VILLAGE GREEN AT
EAST COBB

PETITION NO: Z-59

ZONING COMMENTS:

SITE PLAN
SCALE

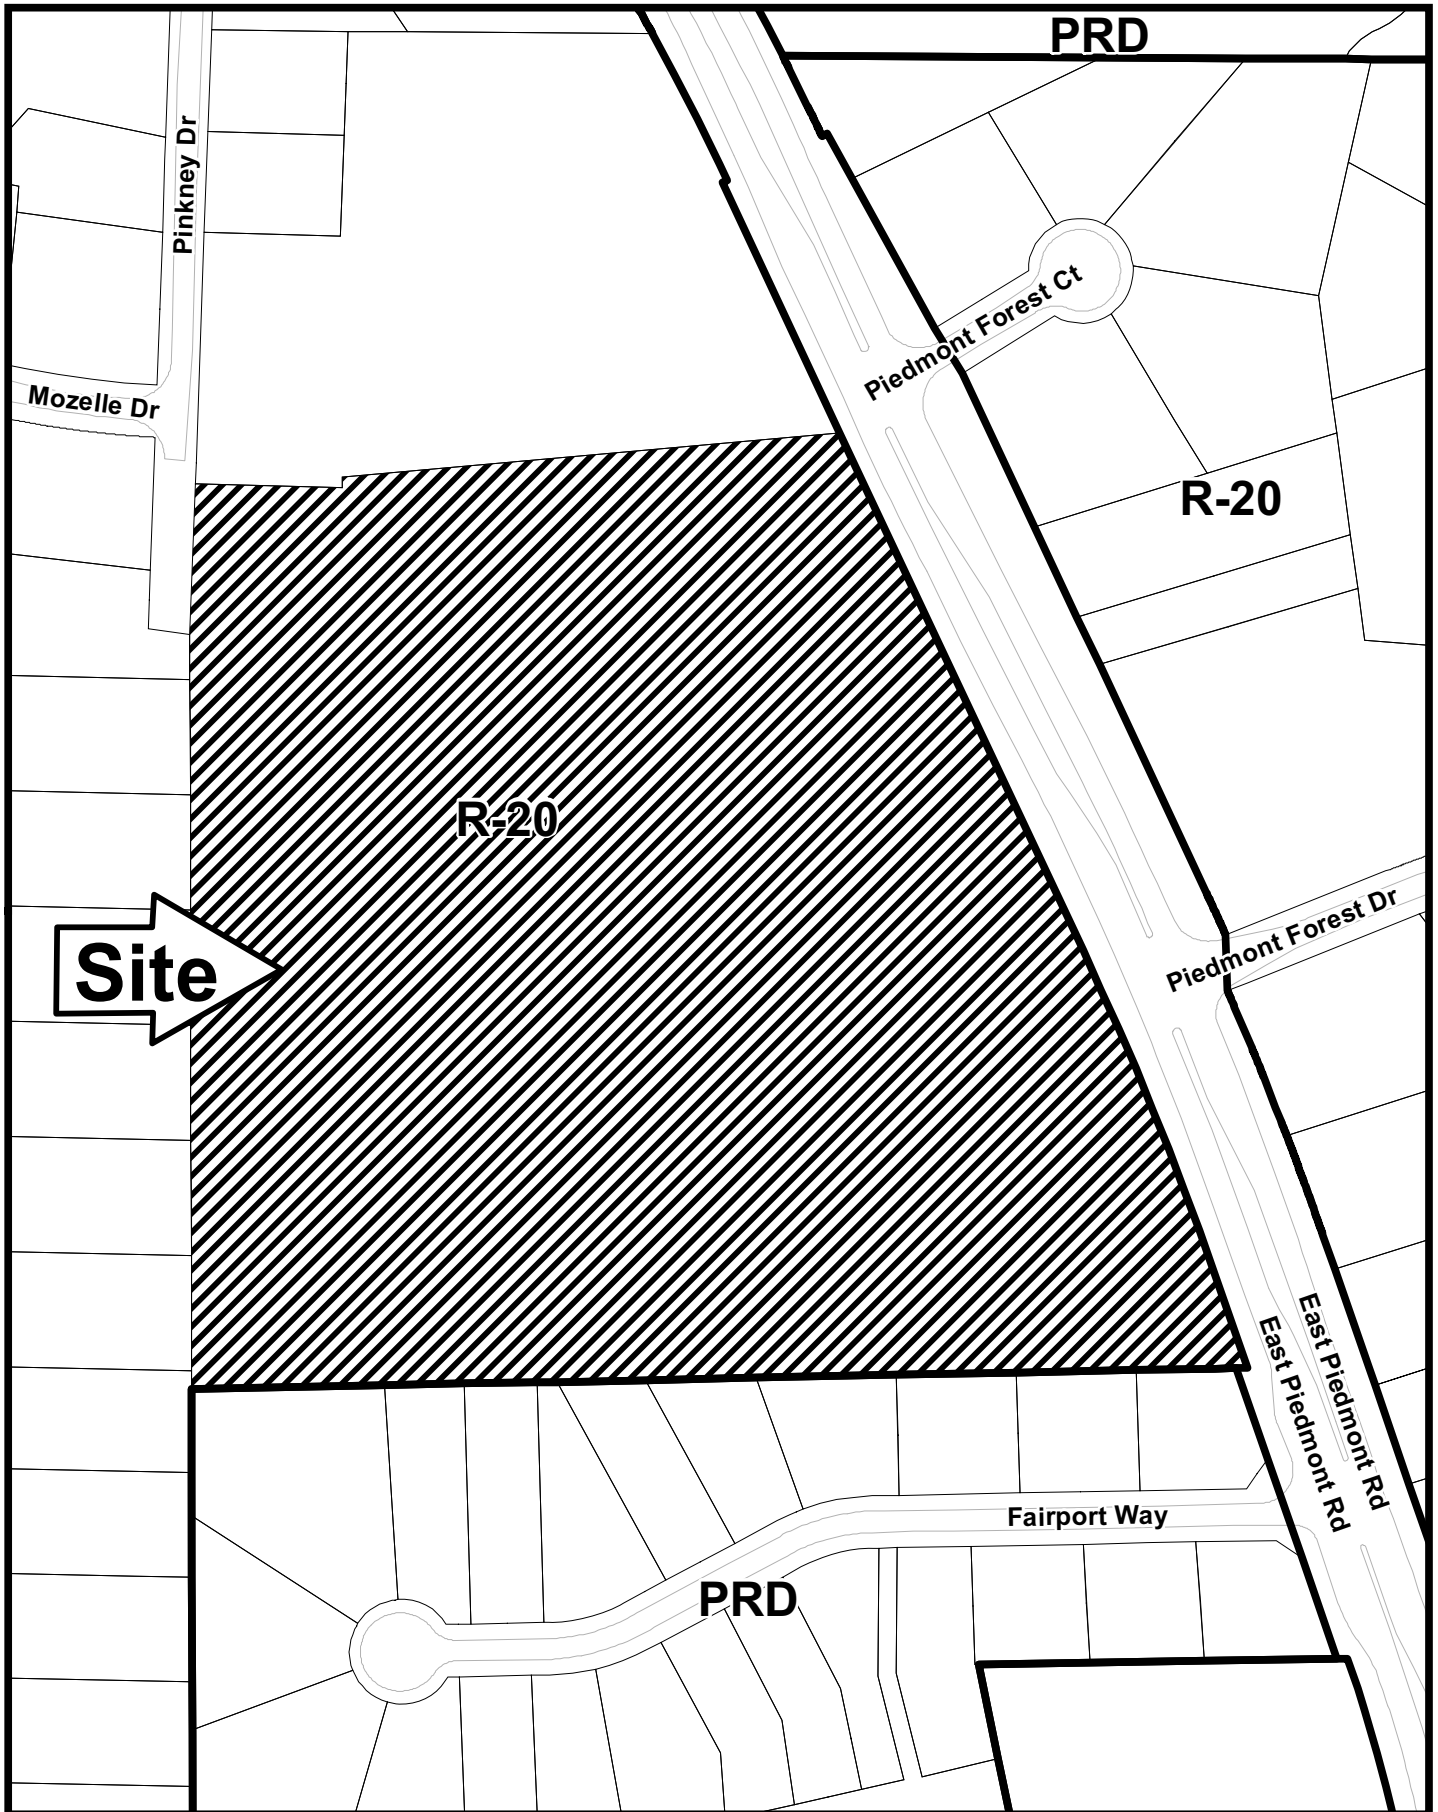
Applicant is requesting the Residential Senior Living (RSL) zoning category for the development of a 57-unit non-supportive senior living community. The minimum unit size will be 1,800 square feet and greater. The units will be traditional and will range in price from \$295,000 and up. The development will be a gated private road community. The proposed site plan, last revised August 30, 2013 and received by the Zoning Division on September 9, 2013, indicates a 40-foot perimeter and a 20-foot landscaped buffer along the perimeter of the development. The Zoning Ordinance requires a 30-foot perimeter setback. The proposed plan also includes a village green park in the center of the development and common/recreational areas on the southern portion of the property. Per the Zoning Ordinance, non-supportive developments are to have 15 feet between buildings.

- No Stormwater controls shown _____
- Copy of survey is not current – Additional comments may be forthcoming when current site conditions are exposed.
- No site improvements showing on exhibit.

- A. It is Staff's opinion that the applicant's rezoning proposal will not permit a use that is suitable in view of the use and development of adjacent and nearby properties. Adjacent and nearby properties are developed as single-family residential subdivisions with lower densities than the applicant's proposal.

- E. It is Staff's opinion that there are existing and changing conditions affecting the use and development of the property which give supporting grounds for approving the applicant's rezoning proposal, but limiting the density to a maximum of 2.5 units per acre. Applicant's proposal does not meet the density range of the *Cobb County Comprehensive Plan* for the LDR category (1-2.5 units per acre). The proposed development of 3.32 units per acre is at a higher density than other developments in the area. Staff is also concerned that the proposed plan does not meet the 15 feet between buildings requirement of the RSL (Non-Supportive) section on the ordinance.

- Maximum of 2.5 units per acre;
- Detached units;
- Final site plan to be approved by the Board of Commissioners;
- Fire Department comments and recommendations;
- Water and Sewer Division comments and recommendations;
- Stormwater Management Division comments and recommendations; and
- Department of Transportation comments and recommendations.
